**Request for Additional Information No. 378(4409, 4513, 4490), Revision 2
Supplement 3**

U. S. EPR Standard Design Certification

Docket No. 52-020

**QUESTIONS for Containment and Ventilation Branch 1 (AP1000/EPR Projects)
(SPCV)**

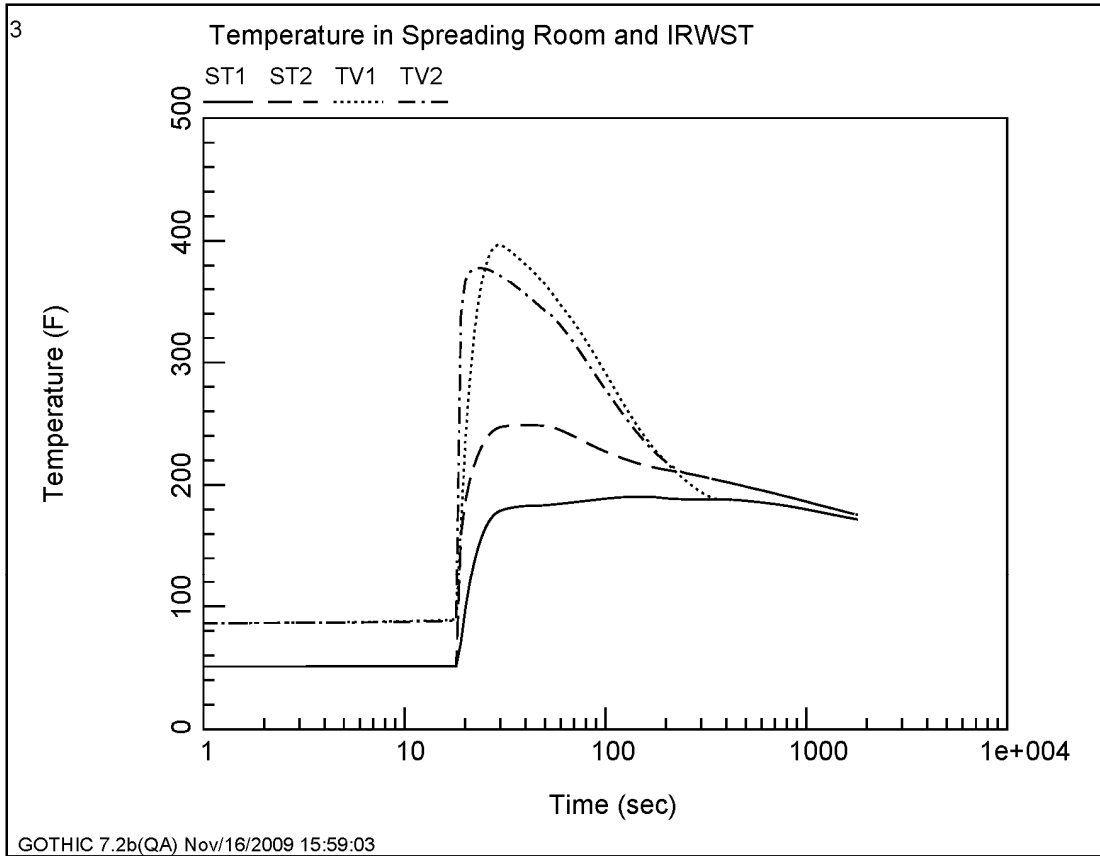
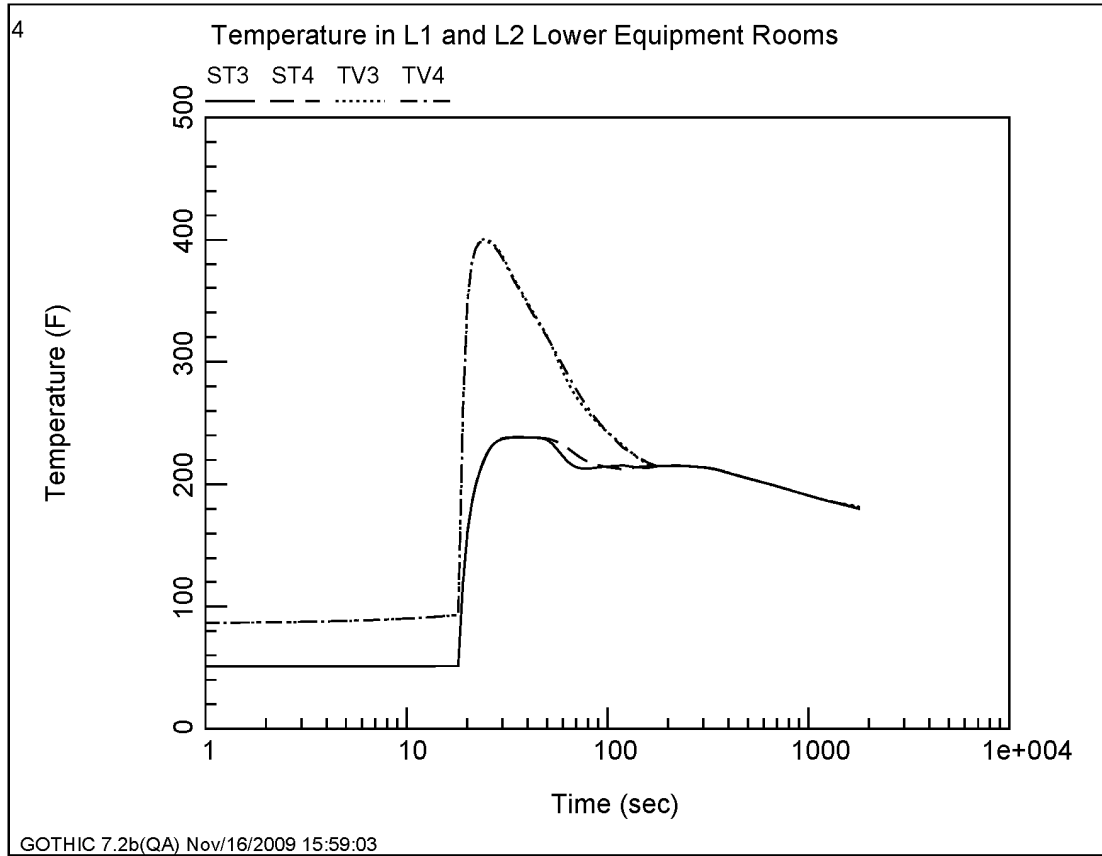
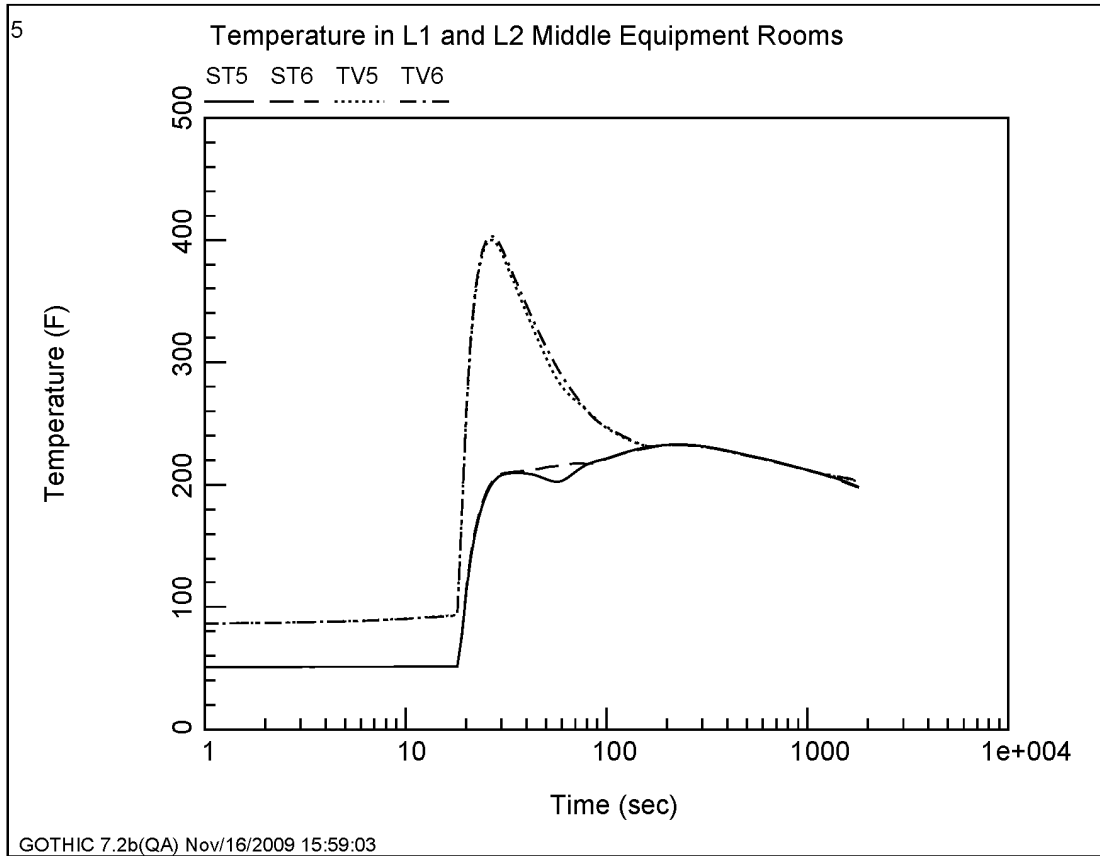
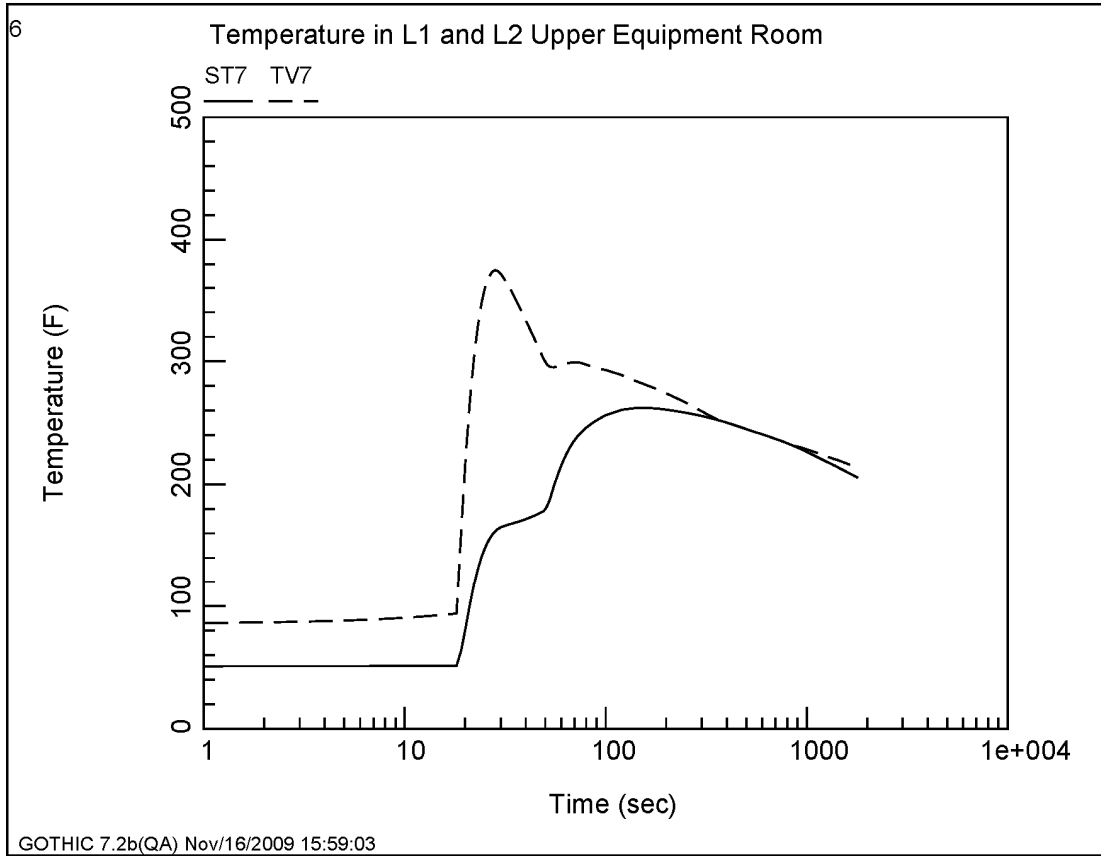
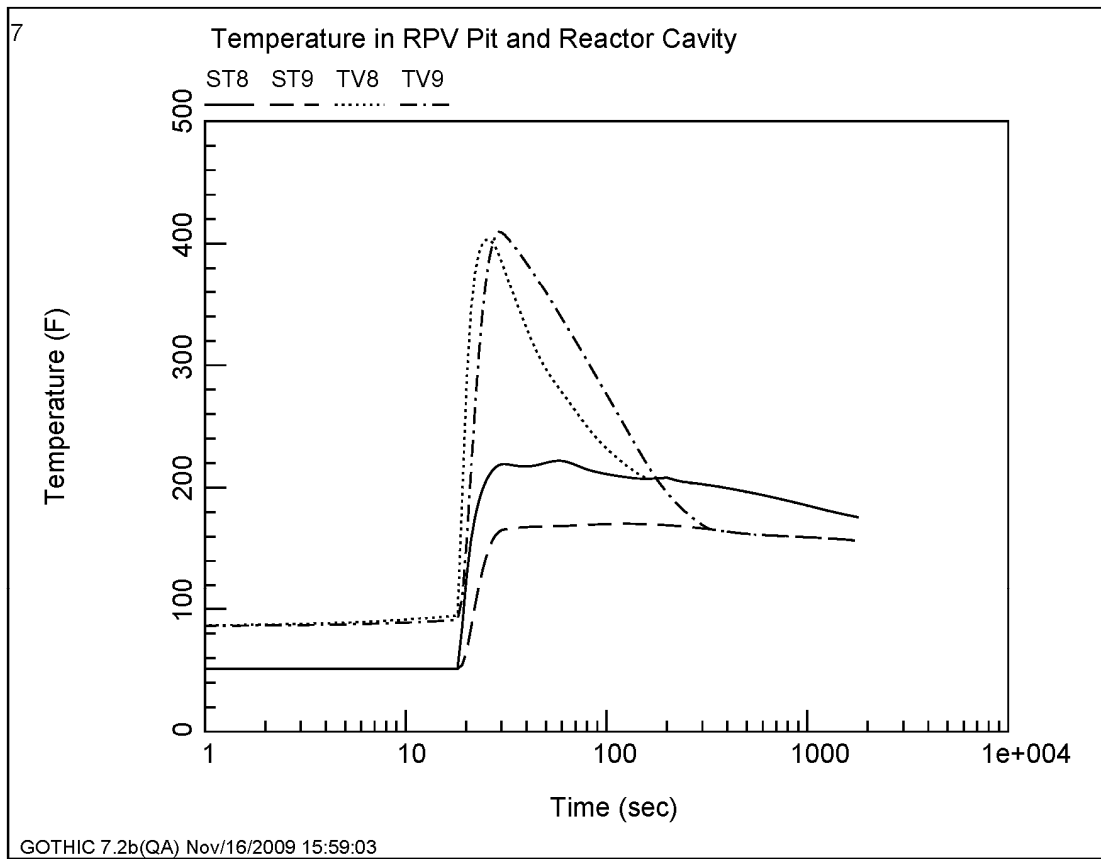
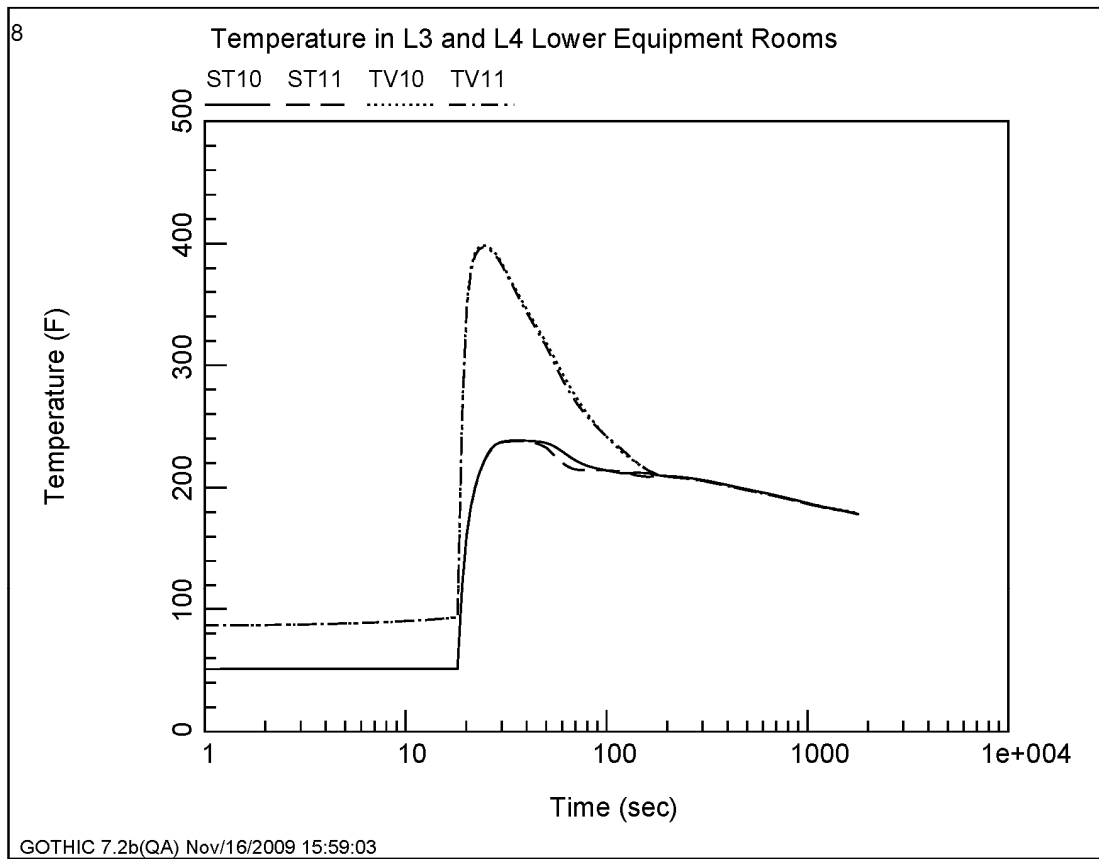
- d. Time history atmospheric temperature plots for lumped parameter nodes below the dome (nodes 1-30, excluding node 25). The atmospheric temperature plots should include both gas (vapor) and saturation temperatures.

- c) The time history plots for maximum atmospheric temperature location and pressure are given in Figures 06.02.01-89-1 and 06.02.01-89-2.
- d) The time history atmospheric temperature plots for the lumped parameter nodes below the dome (nodes one through 30, excluding node 25) are given in Figures 06.02.01-89-3 through 06.02.01-89-18.

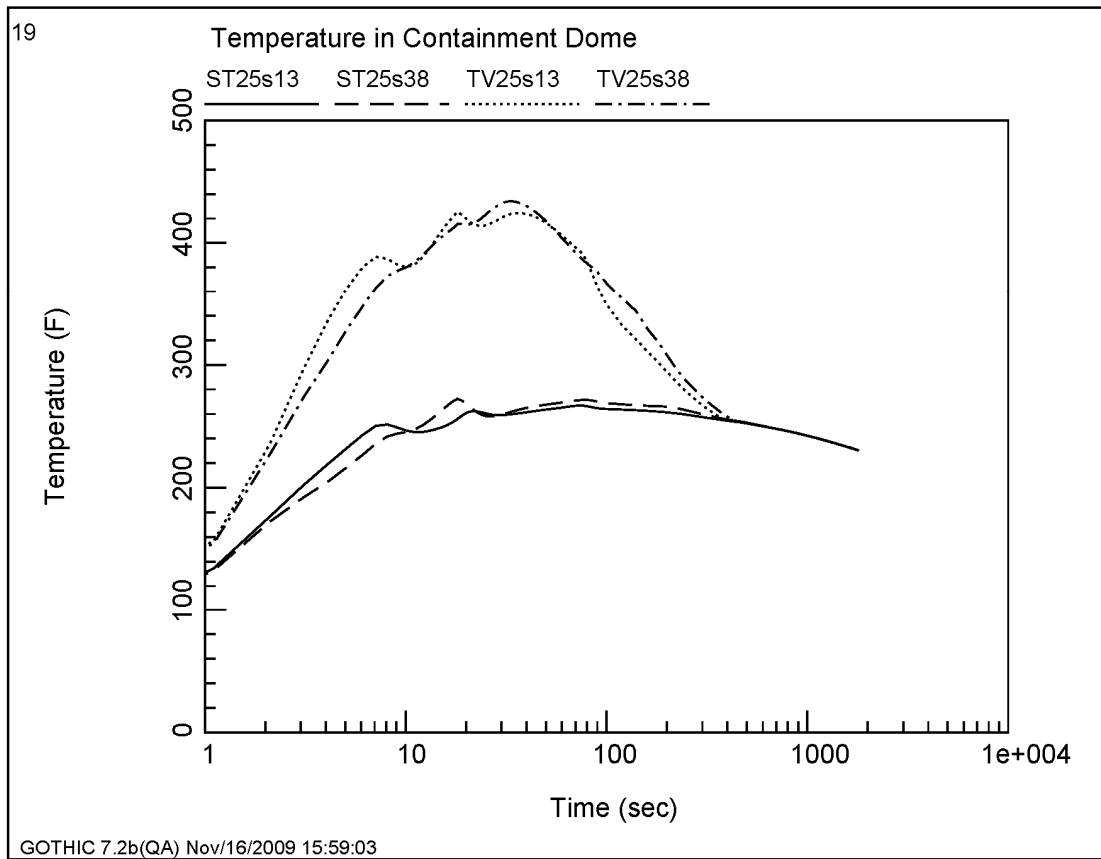
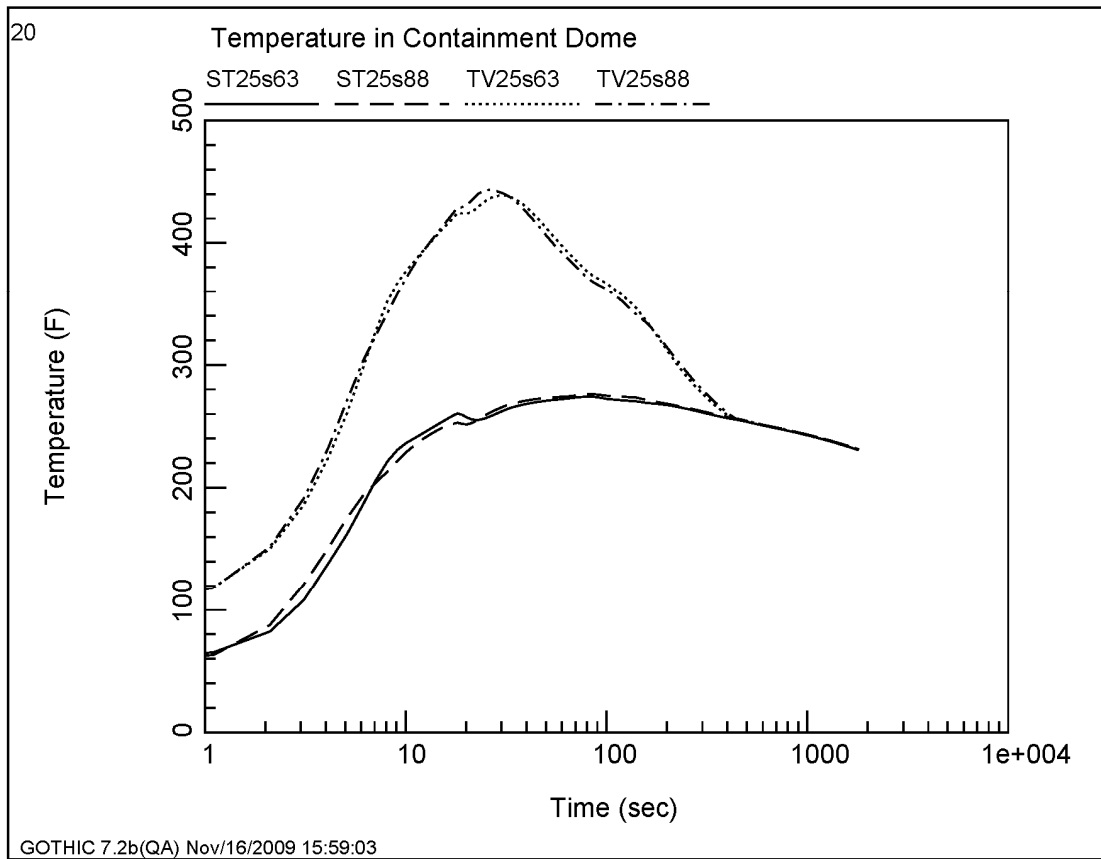
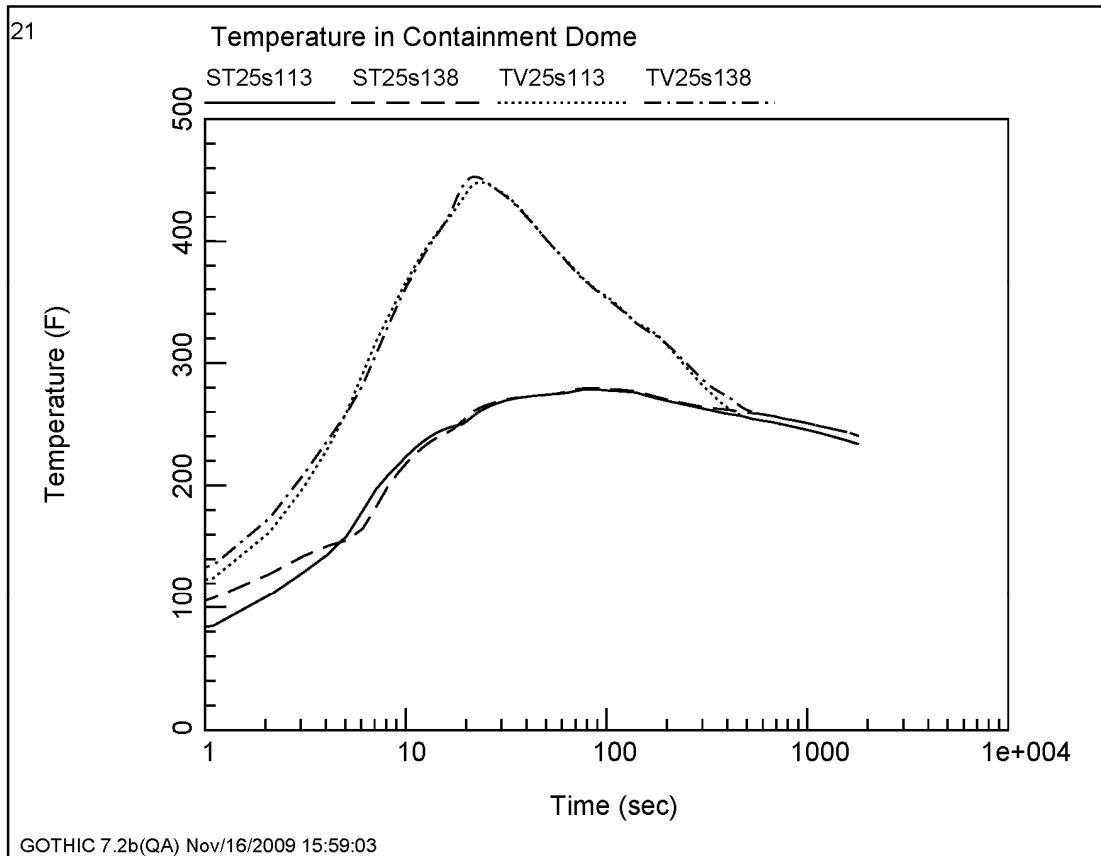
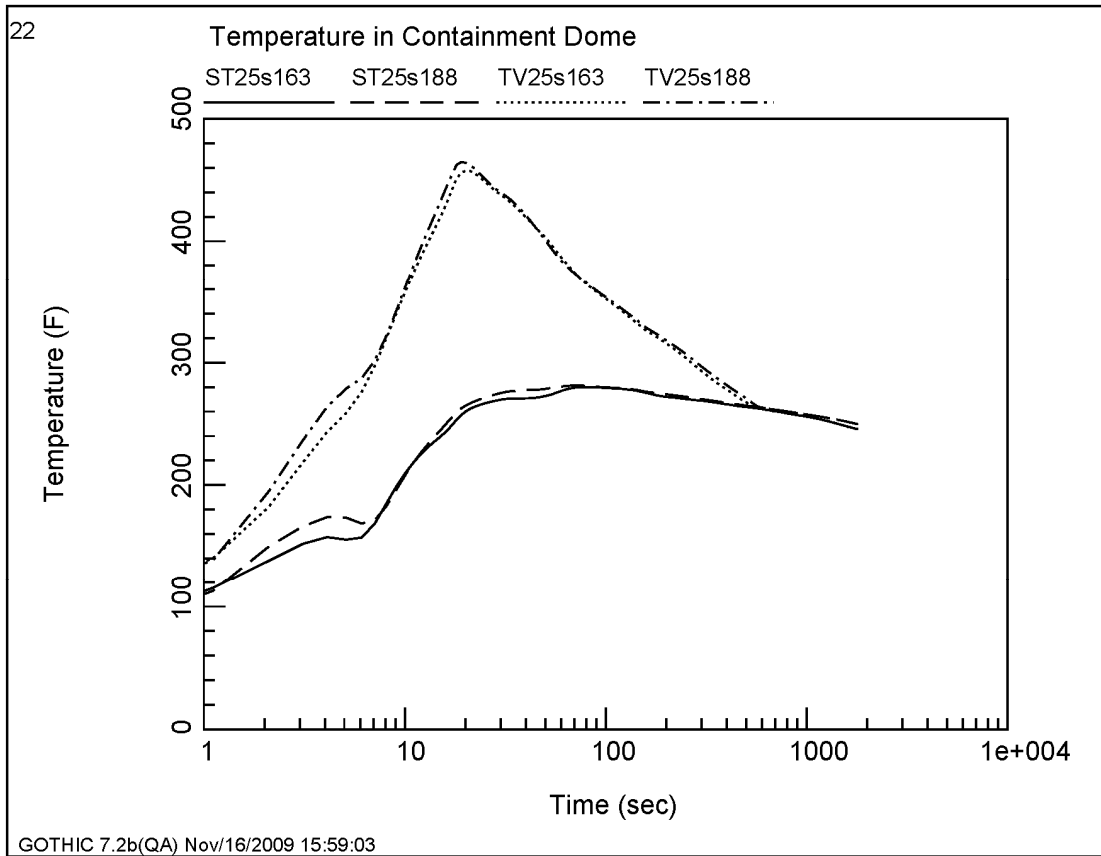
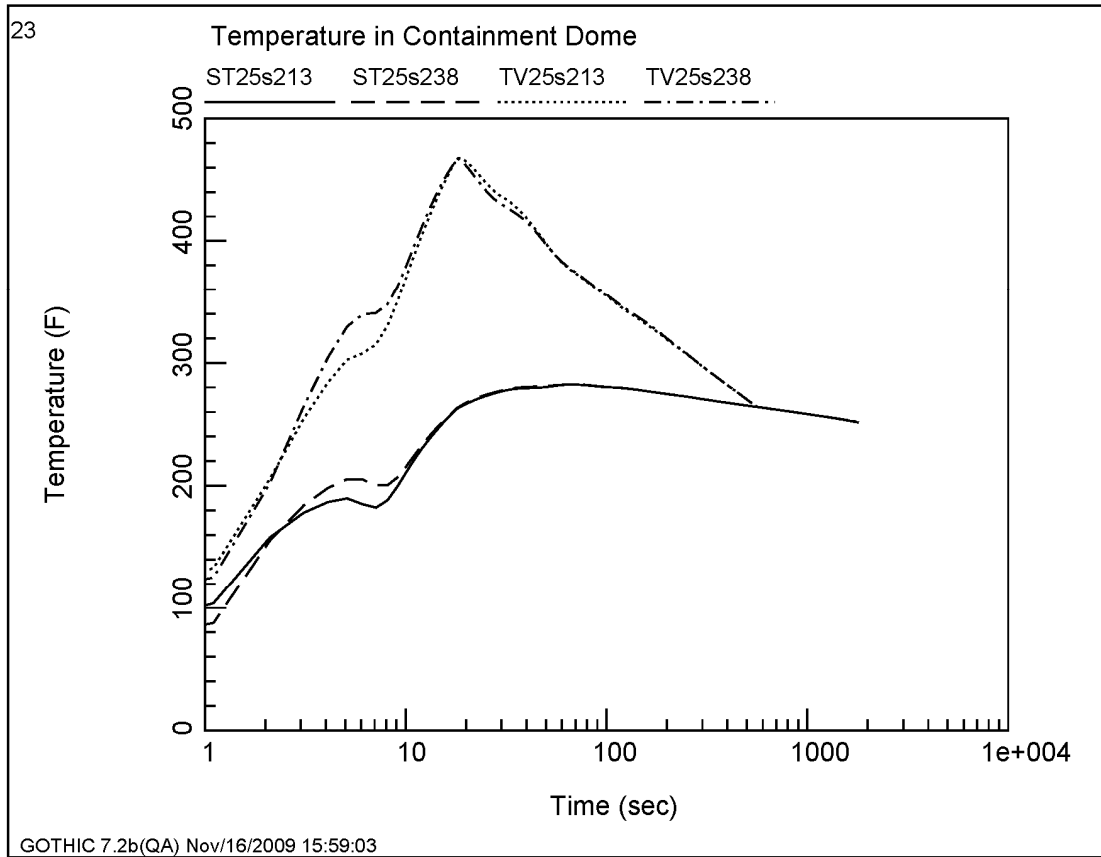
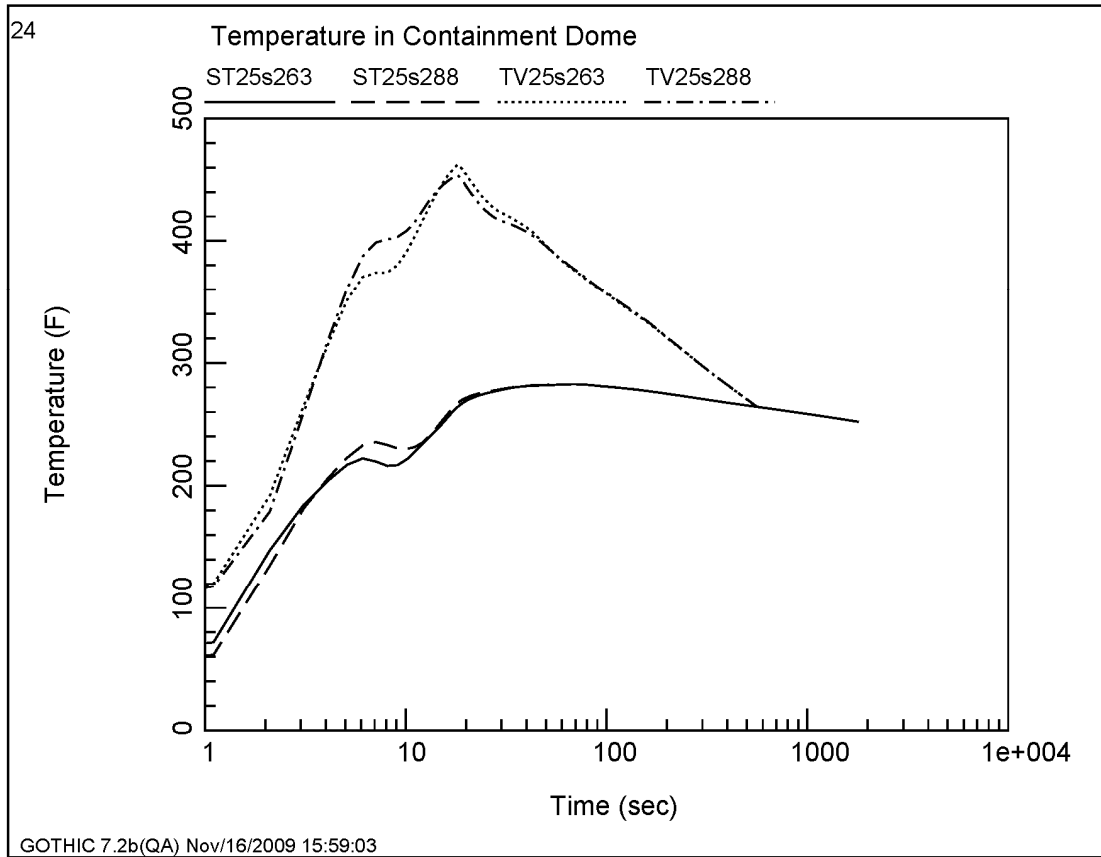
- e. Time history atmospheric temperature plots for subdivided nodes in the dome region nearest the containment centerline (19 vertical locations). The atmospheric temperature plots should include both gas (vapor) and saturation temperatures.

- e) The time history atmospheric temperature plots for subdivided nodes in the dome region nearest the containment centerline are given in Figures 06.02.01-89-19 through 06.02.01-89-28.
